HISTORIC AND DESIGN REVIEW COMMISSION

HDRC CASE NO: 2018-456
COMMON NAME: 613 CHESTNUT ST
ADDRESS: 424 LAMAR ST
618 LIVE OAK
LEGAL DESCRIPTION: NCB 529 BLK 2 LOT 6
NCB 543 BLK 32 LOT 19 (HEALY-MURPHY CENTER SUBD)
ZONING: IDZ, D,HS
CITY COUNCIL DIST.: 2
DISTRICT: Dignowity Hill, Healy-Murphy Historic District
LANDMARK: St Peter Claver Church and School
APPLICANT: William Maney
OWNER: William Maney
TYPE OF WORK: Relocation of structure from 613 Chestnut St / 618 Live Oak to 424 Lamar St
APPLICATION RECEIVED: September 25, 2018
60-DAY REVIEW: November 24, 2018
REQUEST:

The applicant is requesting final approval to:

**Historic and Design Review Commission
 Design Review Committee
 Report & Recommendation**

SITE PLAN

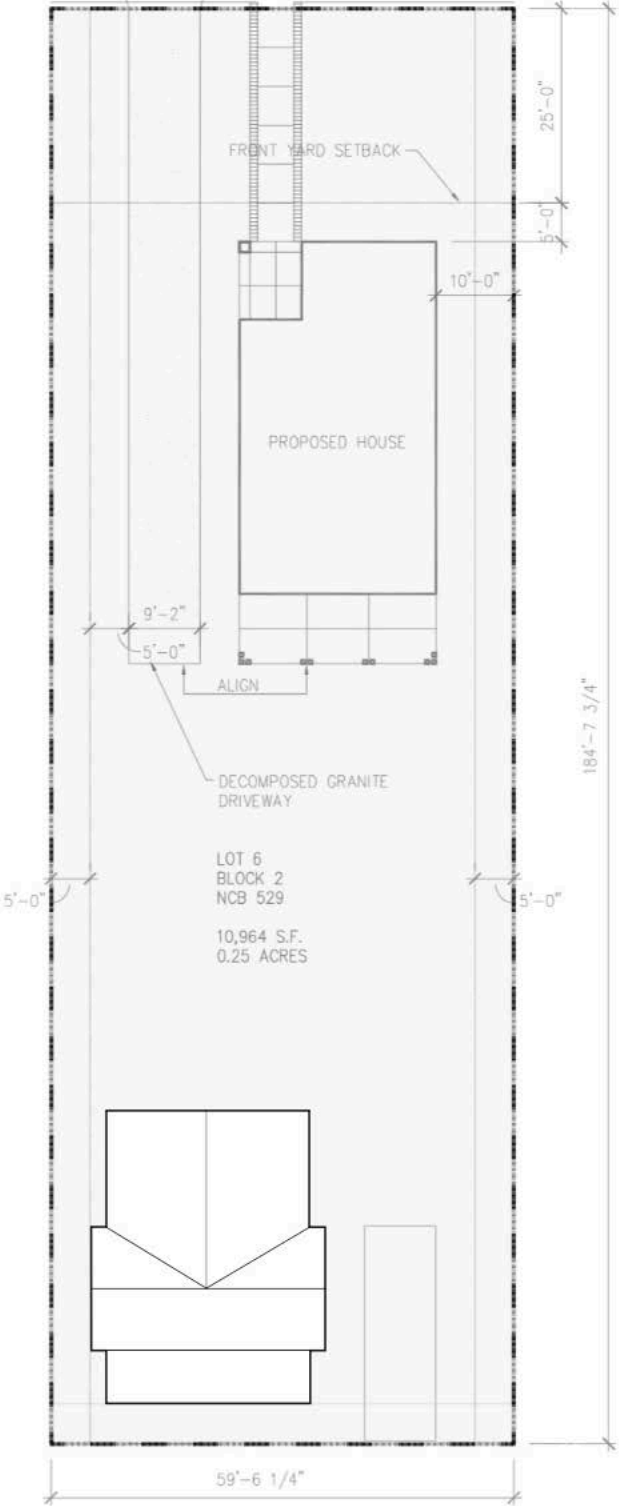
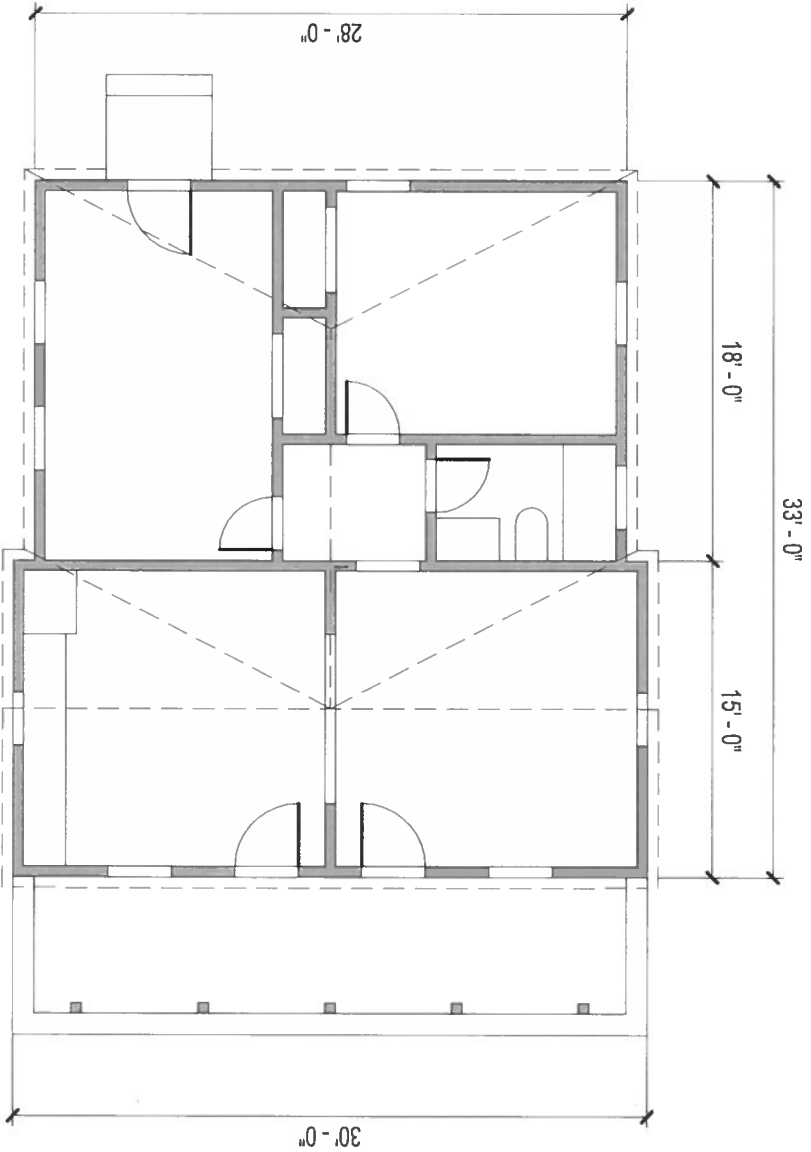
- j. **HARDSCAPING & LANDSCAPING** – The applicant has indicated a rear driveway to be introduced on site off Fayn Way on the submitted conceptual site plan. According to the Historic Design Guidelines for Site Elements, driveways that are similar to the historic configuration found on site or in the district should be incorporated. According to Guideline 5.B.i, driveways similar in material found in the district should be used. Rear driveways off alleys are characteristic of the Dignowity Hill Historic District. Additionally, no walkways or landscaping elements are indicated at this time. The applicant is responsible for submitting a comprehensive site plan to staff that indicates all hardscaping materials, locations, and dimensions, as well as any new landscaping to be introduced to the site prior to the issuance of a Certificate of Appropriateness.

- i. That the applicant provides a comprehensive site plan to staff for review and approval that indicates the dimensions, locations, and materials of all hardscaping, landscaping, mechanical equipment, and mechanical equipment screening, if applicable, as noted in findings j and k.

SITE PLAN: ADD REAR DOOR COVER DETAIL TO DRAWINGS.

SETBACK = OK, NO PREVAILING SETBACK EXISTING. ZONING = OK WITH SETBACK.

TREE WOULD BE REMOVED.

EAST ELEVATION

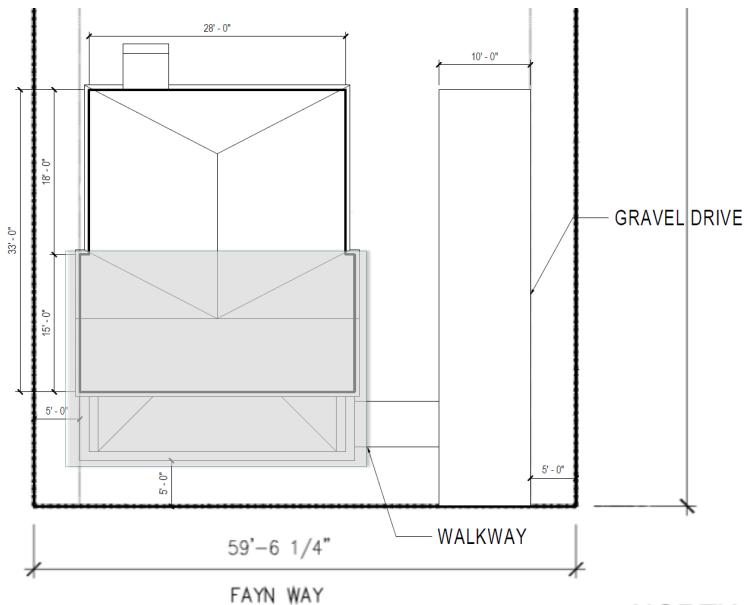
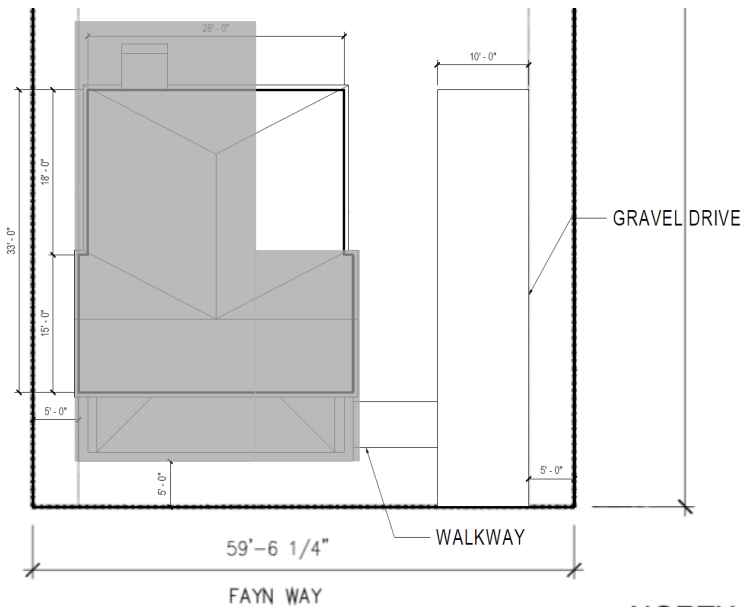
- m. SCALE AND MASSING – The applicant has proposed to construct a 1-story addition to the rear of the original structure. The ridgeline is proposed to match that of the existing structure. Staff finds the general location consistent with the Guidelines, but finds that the roof height of the addition should be reduced to distinguish the original structure from the addition. Lowering the roofline would create a subordinate condition which is more consistent with the Guidelines.

- n. ROOF – The applicant has proposed a new standing seam metal roof with a hipped configuration. As noted in finding n, staff finds that the ridge height should be reduced and the addition’s roofline should be subordinate to the existing structure, but finds the integration of a hipped roof appropriate.

FOR ADDITION DETAILING: DROP DOWN ROOF TO MITIGATE MAPS. TWO ROOF SHAPES ON BACK, TAKE PLATE DOWN 1-2 FEET. WILL MINIMIZE IMPACT ON EXISTING STRUCTURE COULD BE HIP OR GABLE + SHED OVER OTHER PORTION.

ADDITION = METAL HORIZONTAL SIDING.

CF: VERTICAL ORIENTATION WOULD BE MORE LIKE BOARD & BATTEN. NOT A PREVAILING

PATTERN OF MATERIALS ON ALLEY.
NEED TO ARTICULATE USE CAREFULLY & HAVE A BACKUP CHOSEN. MAYBE FLAT SEAM METAL?

- i. That the applicant reduces the height of the ridgeline to be subordinate to the existing structure as noted in findings m and n. The applicant is required to submit updated dimensioned drawings to staff for review and approval prior to receiving a Certificate of Appropriateness.

- iii. That the applicant submits comprehensive details for the proposed metal siding as noted in finding p.
